# Hardware Change Notification

Beginning November 5<sup>th</sup> the SolarEdge single and three phase inverters have a revised connection panel, with larger communication glands, as pictured below.

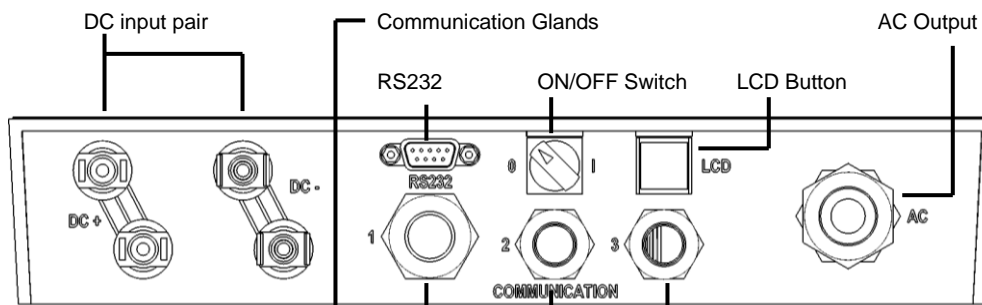
The new glands are numbered and can be used as follows:

Gland	Size [mm]	Function	Wire Size
1	20	Ethernet connection (CAT5/6) or ZigBee antenna	4.5-7 mm
2 +3	16	RS485 and ZigBee antenna	2-7 mm
